## Paper os-2011-68 Response to reviews

### Martinson and Mckee, Transport of warm upper circumpolar deep water onto the Western Antarctic Peninsula Continental Shelf

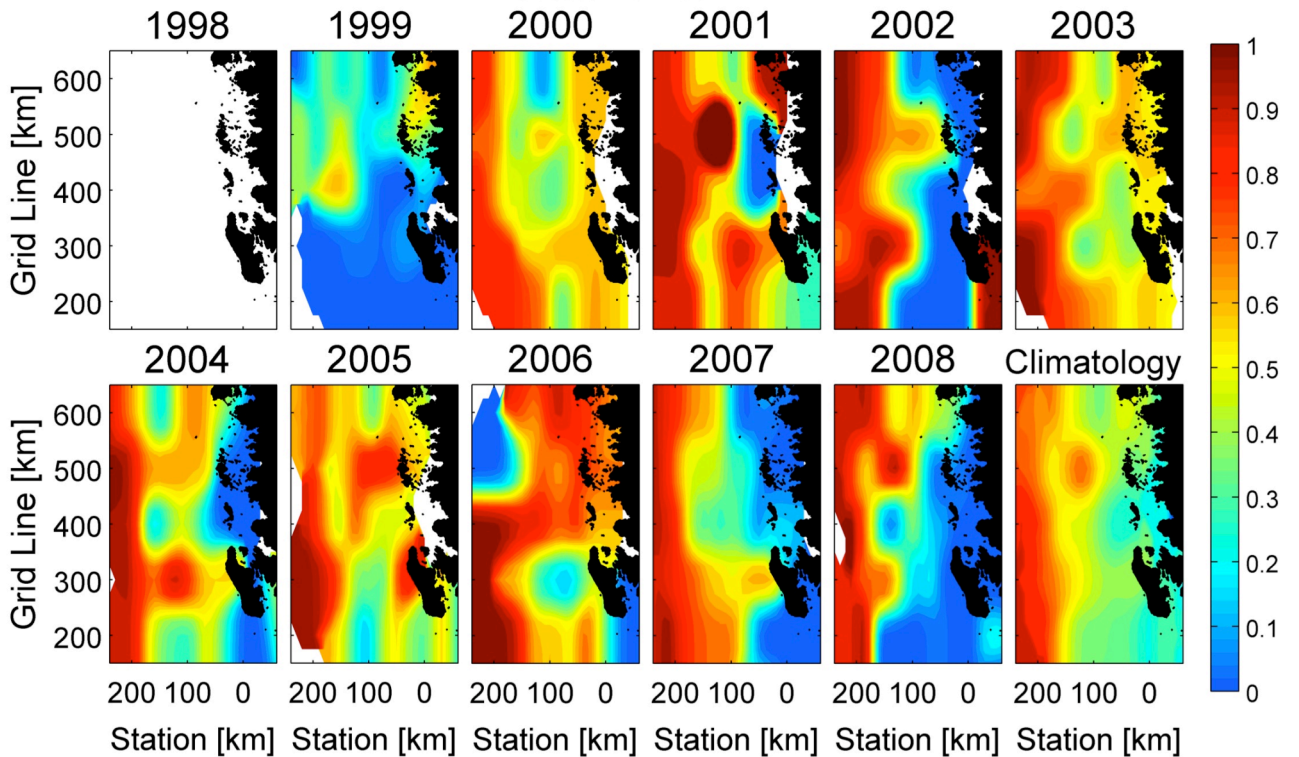
*2) In particular it would be helpful to clarify the water mass definitions and justify the exclusion of LCDW from consideration, particularly given that earlier studies of CDW intrusion onto the WAP shelf have identified both UCDW and LCDW intrusions. The derivation of the UCDW fraction shown in Figure 3 could be clarified at this point. I appreciate that it is explained in MSISV08, but it is important for the interpretation of Figure 3. Critically one end-member of the “three water mass mixture” is so dense that it could never contribute directly to the mixture of waters on the shelf. This gives a bias towards high fractions of UCDW. For example, using this system classically-defined LCDW becomes something like 80-90% UCDW and 10-20% DW. However, LCDW is a water mass in its own right and is not formed by mixing between the two end members. Wouldn't it be more appropriate to take WW, UCDW and LCDW as the end members for the shelf waters? That would give generally lower fractions of UCDW. It would not alter the basic pattern, but it would highlight the point that UCDW intrusions may not be the whole story, and that other waters derived from the ACC contribute to the water column over some parts of the shelf.*

*4) Something that would help is a more in-depth discussion of Figure 3 (presently only mentioned in passing) as background and motivation for the study. The moorings are focused in the region of high UCDW fraction. This is fair enough as UCDW is slightly warmer and of biologically greater significance (?) than LCDW. However, UCDW is found in mid-water-column, directly below the main pycnocline and well above the seabed, even outside of the troughs. The study was presumably motivated by the desire to understand processes affecting the mid-water column and as a result can give no information on what waters occupy the deeper parts of the shelf, or how they get there. All of this may be self-evident to those more familiar with the WAP and the Pal LTER data (and the underlying motivations for that work), but the paper should be readily accessible to a wider audience. At present the exclusive discussion of UCDW as the dominant water mass everywhere on the shelf might suggest to a non-specialist that the processes discussed could account for all the warm waters on the shelf.*

We agree with your comments, and have added LCDW to the property matrix. MSISV08 had excluded LCDW (as stated in that paper) because its inclusion led to what we considered too much need for the inequality constraints — typically a sign that the model being fit is incorrect or the property matrix is poorly defined for the constituent water masses. The new result and original (no LCDW) result are shown in the included figure. As you deduced, the overall patterns are similar and fractions of UCDW are reduced. The patterns still show Line 300 with UCDW on the shelf, maintaining the reason for locating moorings here. Given that this particular figure serves only the purpose of showing one piece of referenced evidence for the location of the moorings, we have removed it completely. The discussion now simply states that the SO GLOBEC and MSISV08 work suggest placing moorings in the locations we chose (which is still true given the new OMP results). Your comment has encouraged our reassessment of LCDW; it is clearly important here while not altering our conclusions about how UCDW enters the shelf and we appreciate it.

MSISV08 (no LCDW)

With LCDW
